### CURRENT EXISTING 2ND BUILDING DEPARTMENT SUBMITTAL SET

#### BUILDING TYPE 500 | Slab Edge & 1st Floor Plan Composite

© 2019 WILLIAM HEZMALHALCH ARCHITECTS, INC. DBA WHA. | 2017223 | 09-06-19

UNIT PLAN 2A | 1st, 2nd & 3rd Floor Plans & Options

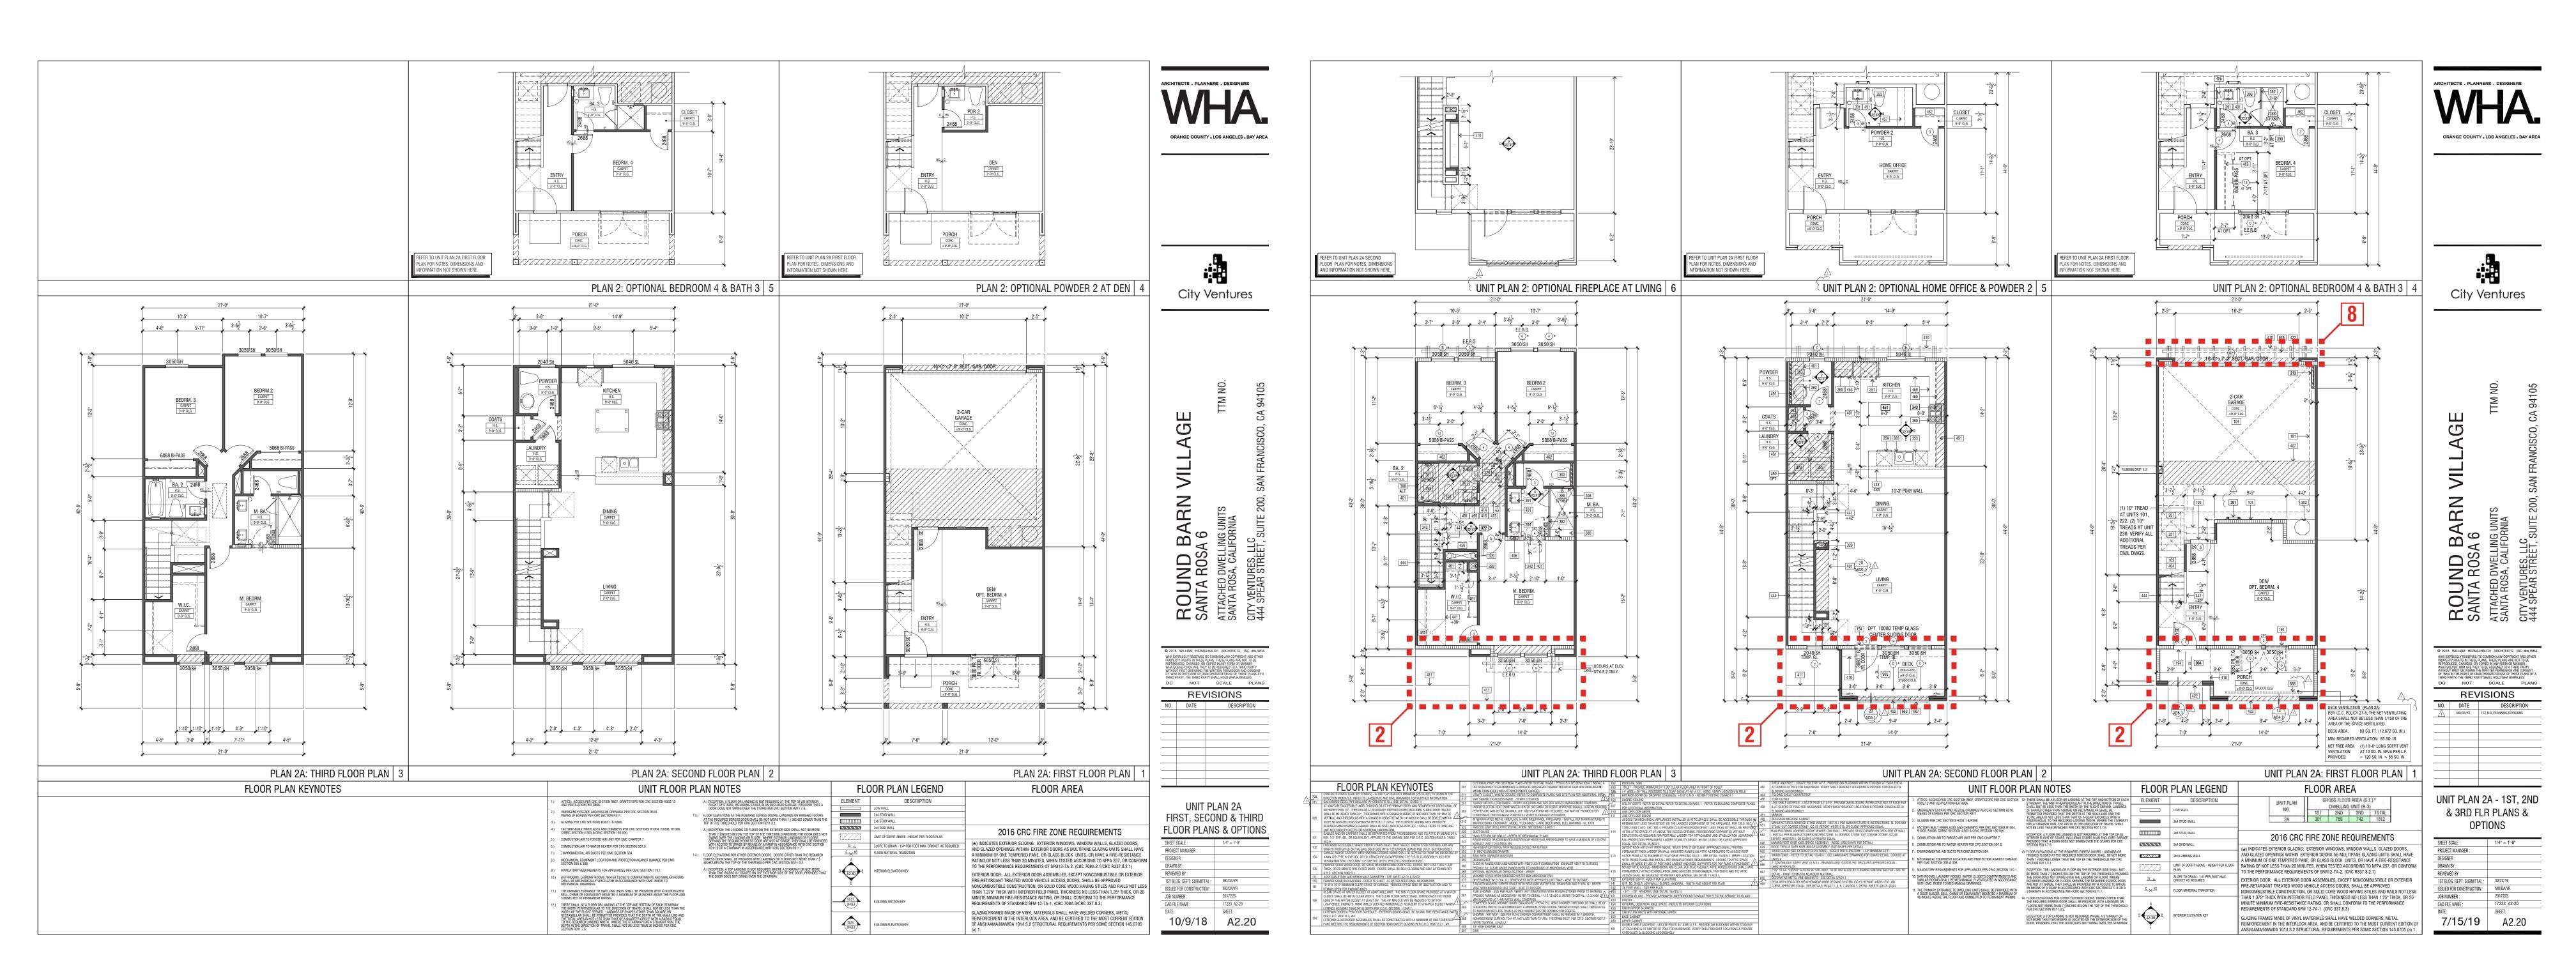
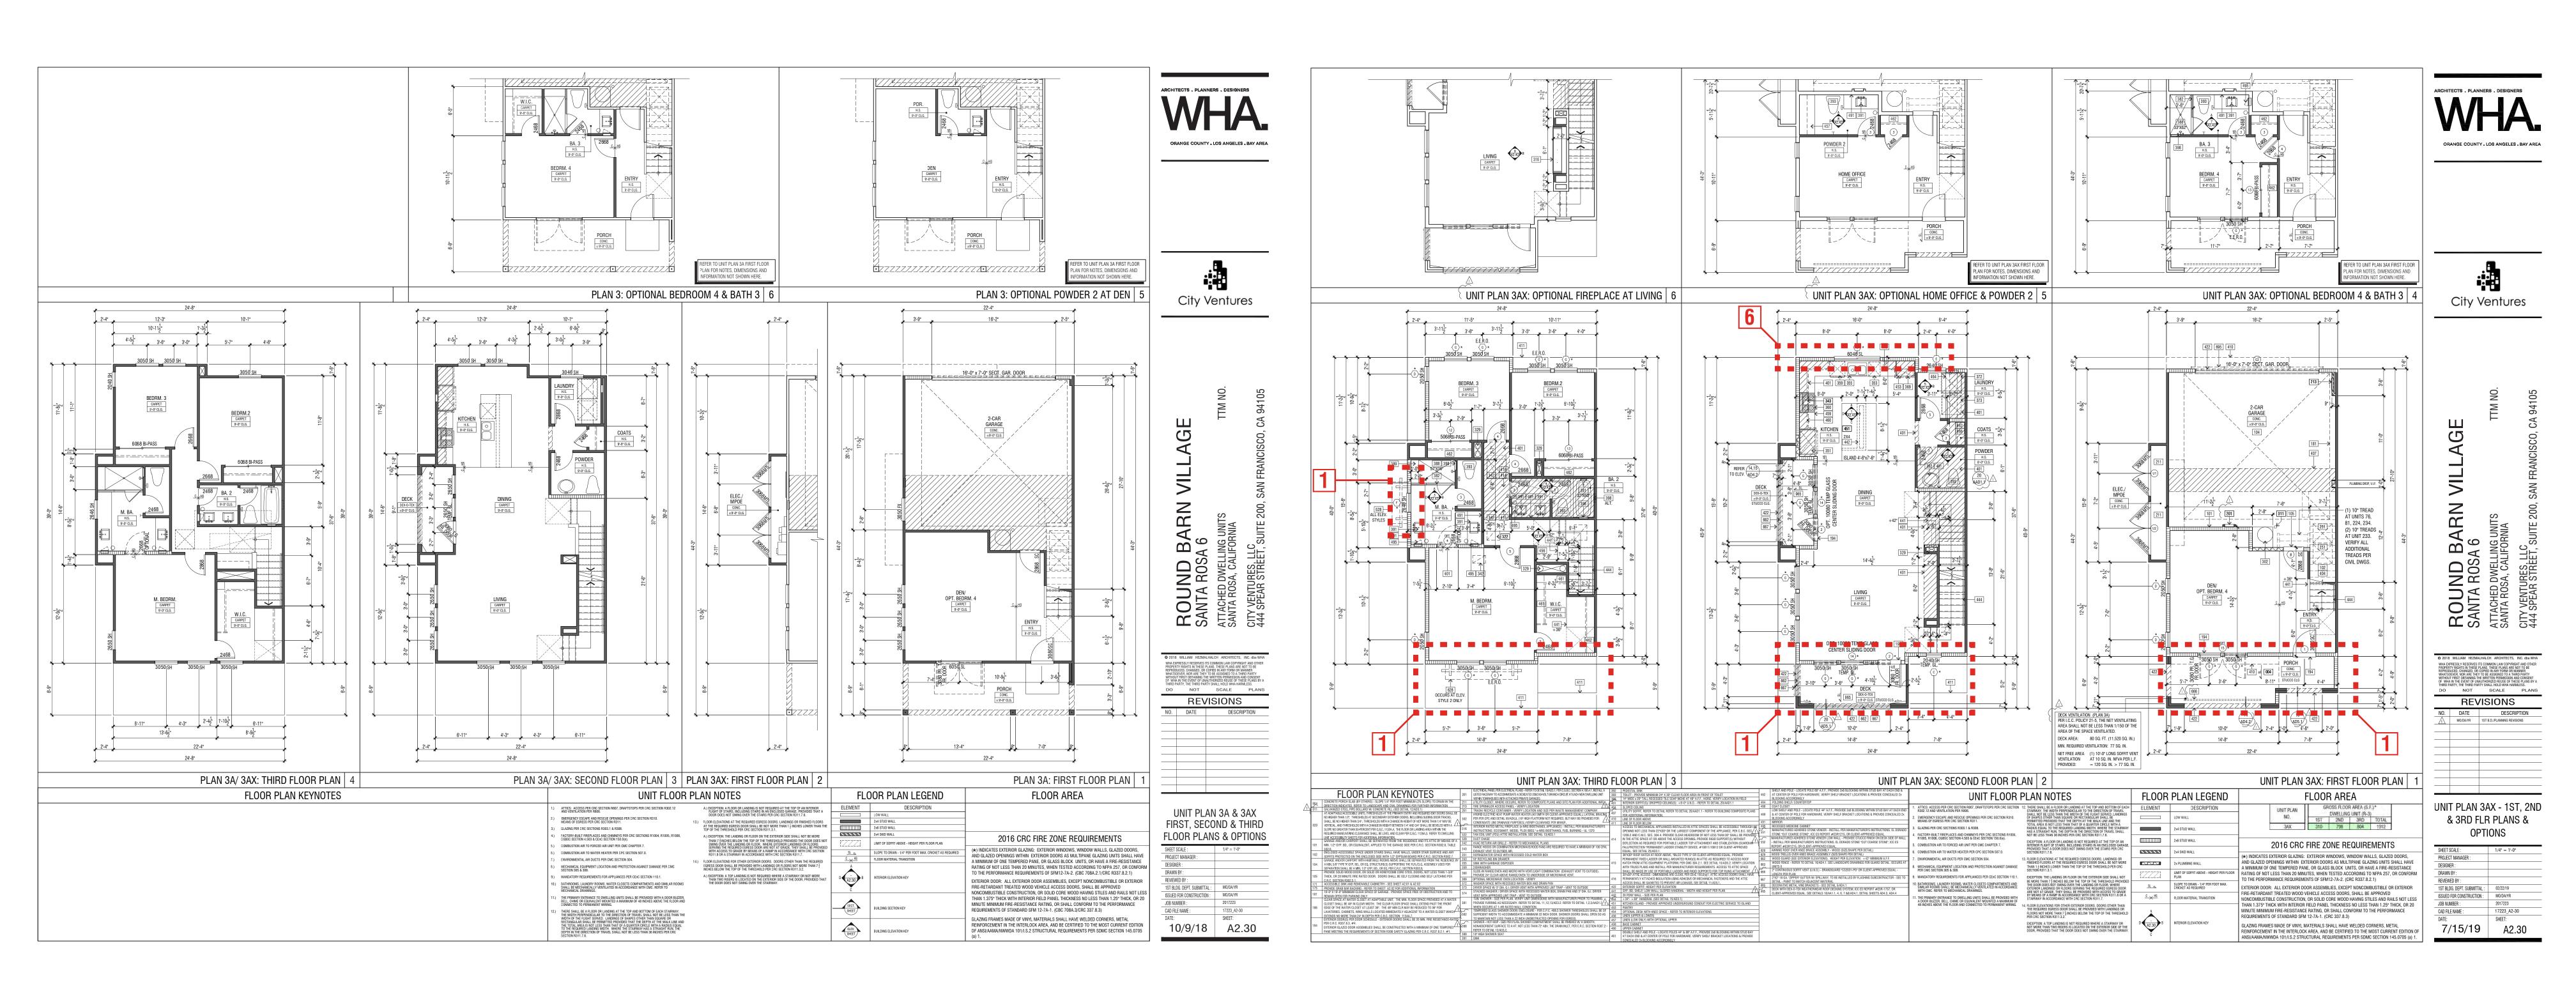
- 2 Unit 2A Added Covered Deck | Created Double Gable | Reconfigured Windows | Removed Awnings Above Windows | Removed / Replaced Horizontal Siding with Boards & Batts.
- 8 Added Trellis at Unit 2A, Typ.

UNIT PLAN 3A & 3AX | 1st, 2nd & 3rd Floor Plans & Options

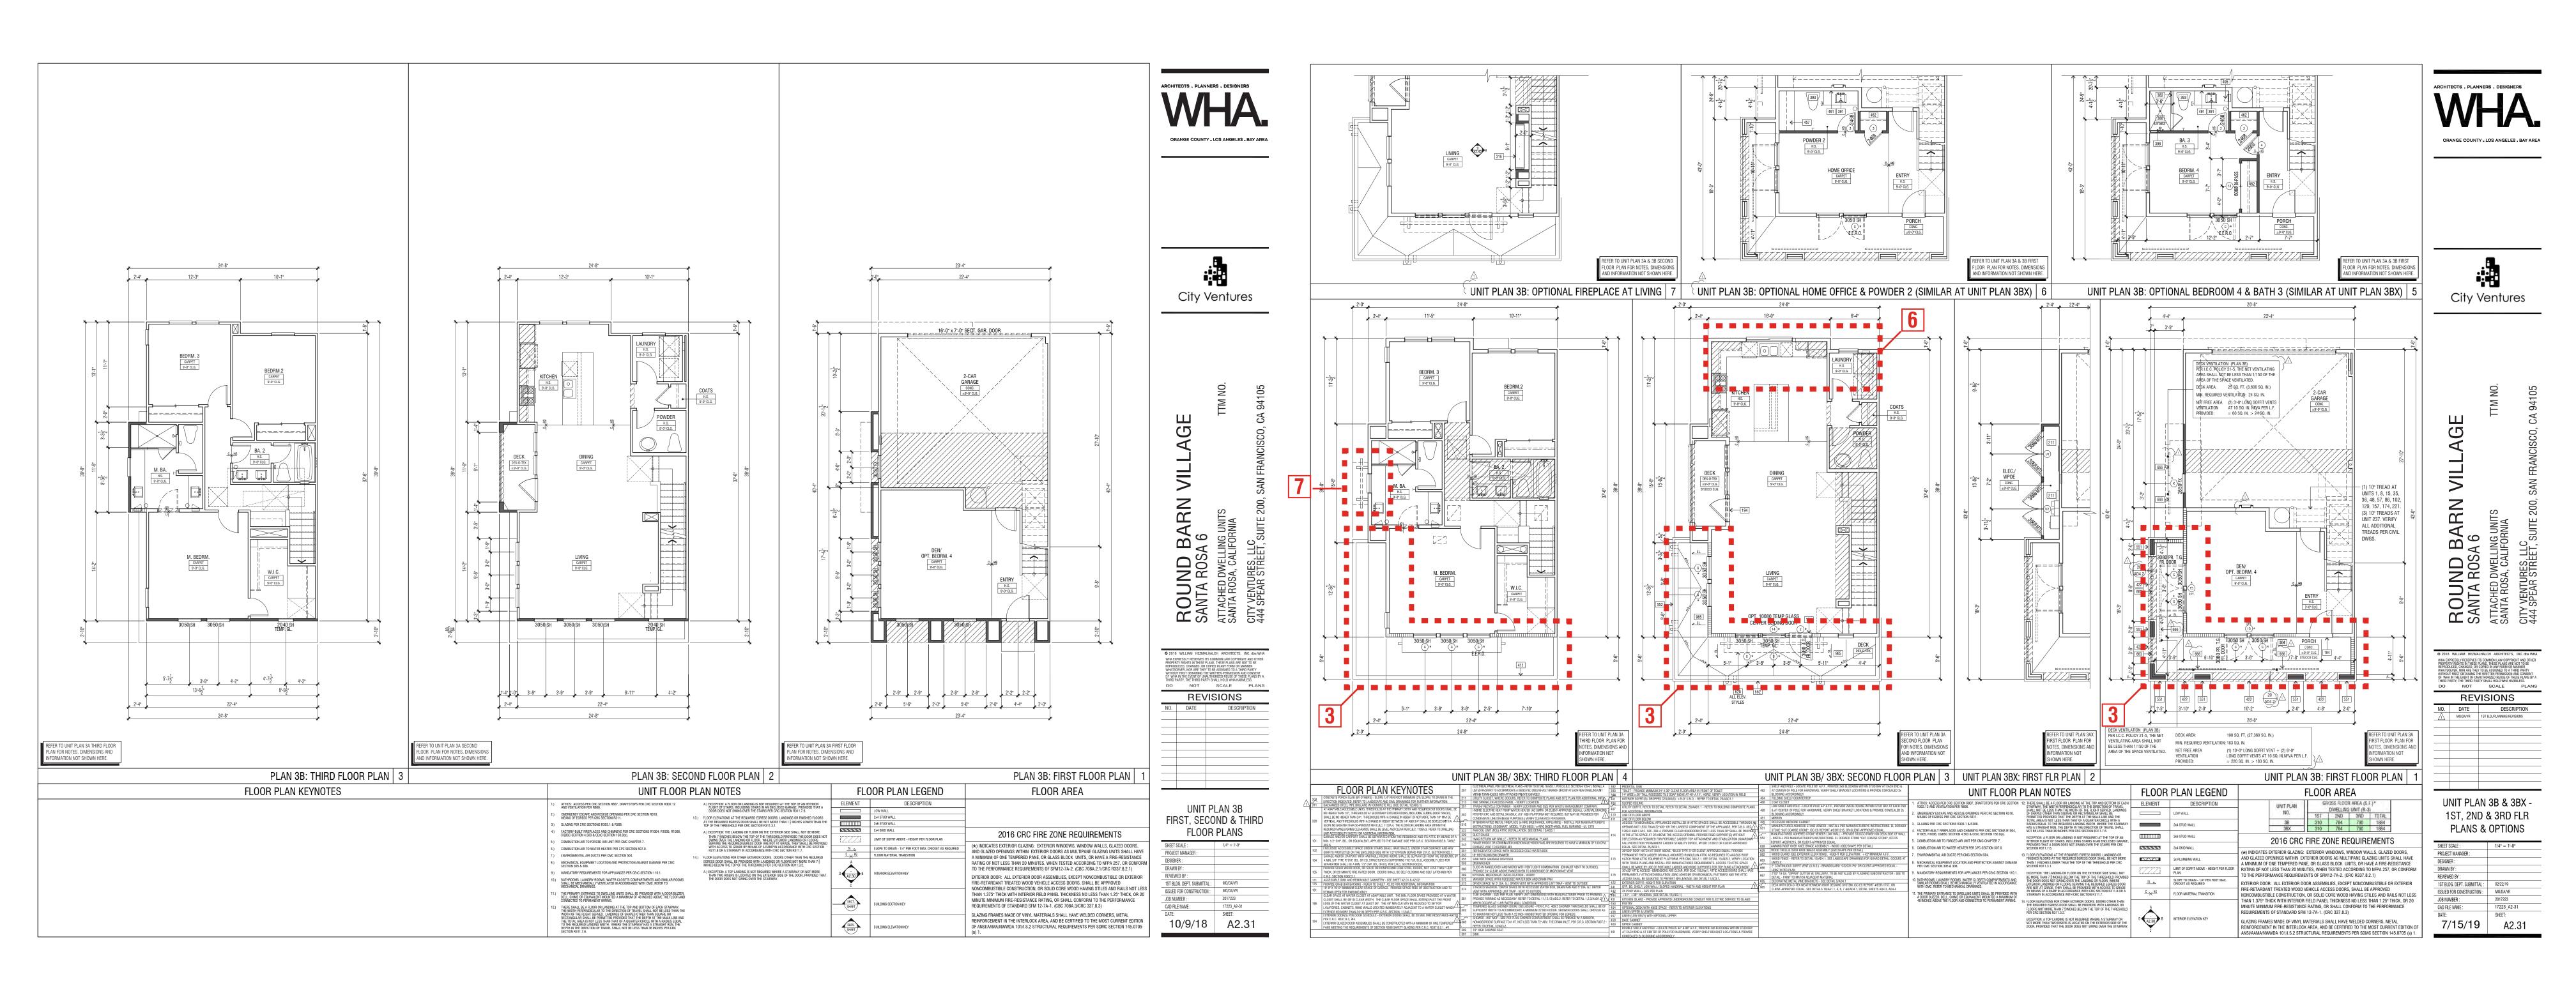
- 1 Unit 3A Added Covered Deck | Created Double Gable | Reconfigured Windows | Removed Awnings Above Windows | Removed / Replaced Horizontal Siding with Boards & Batts.
- 6 Revised Second Floor Massing at Kitchen
